## **129 George Street, Avalon**

### Geotechnical Comments in Regards to New Plans

We have reviewed the existing geotechnical report, the original plans, and the 7 amended plans by J.D Evans and Company, drawings numbered 2141-1 to 2141-7. All Issue A. All dated 10/10/2024.

New Secondary Dwelling at **129 George Street, Avalon**

# SITE PLAN – showing test locations and minimum extent of required shoring

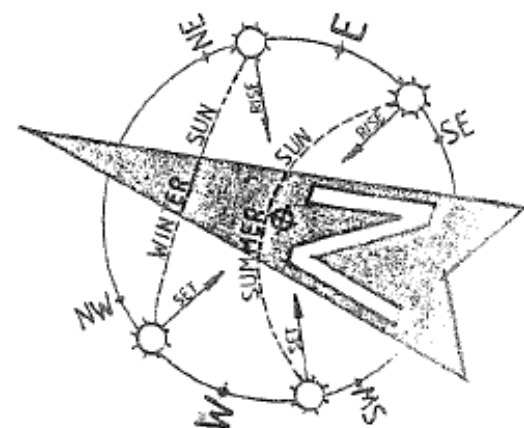
Due to the steep grade of the slope at the location of the proposed development and the proximity of the excavation to the W common boundary, all cut faces through topsoil and clay will need to be temporarily or permanently supported prior to the commencement of the excavation, or during the excavation process in a staged manner, so cut batters are not left unsupported. Suitable temporary support includes the installation of bulka bags until retaining walls are in place. See the site plan attached for the minimum extent of the required shoring in blue. The support will need to be designed / approved by the structural engineer.

Minimum extent of required shoring shown in blue
